Product change notification (PCN)

Title / short description	New side label for VAL-SEC
Affected article category	Surge protection and interference filters
Change category	Marking, Characteristics, Documentation
Change number	CCL240020-01
Reason for PCN/PDN Revision	Addition of several FLT-SEC products.

CCL240020 / new side label for VAL / CL13 SPD Type 2

Change of the label

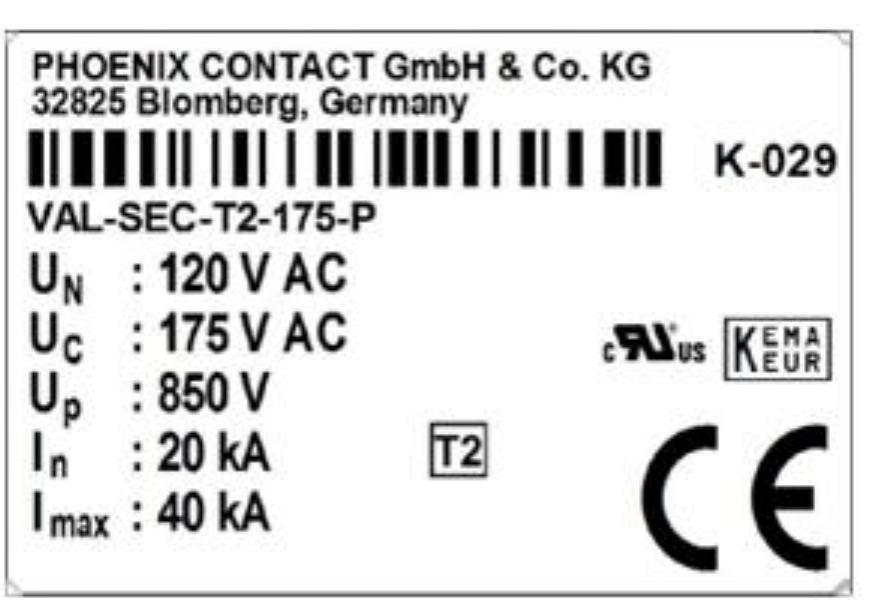
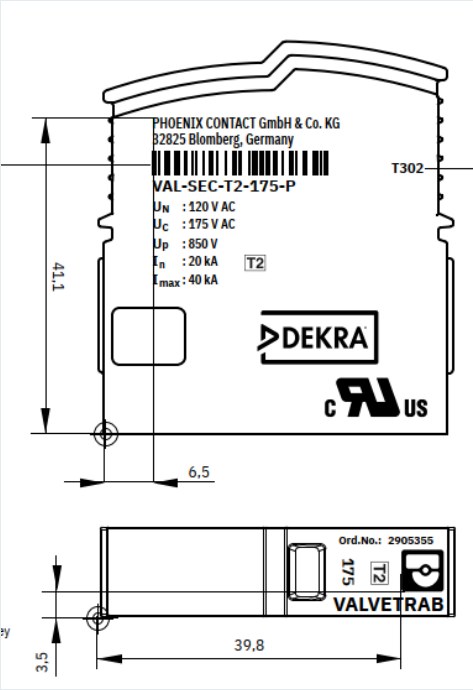
The side label has been changed to printing

Addition of the DEKRA on the now printed label
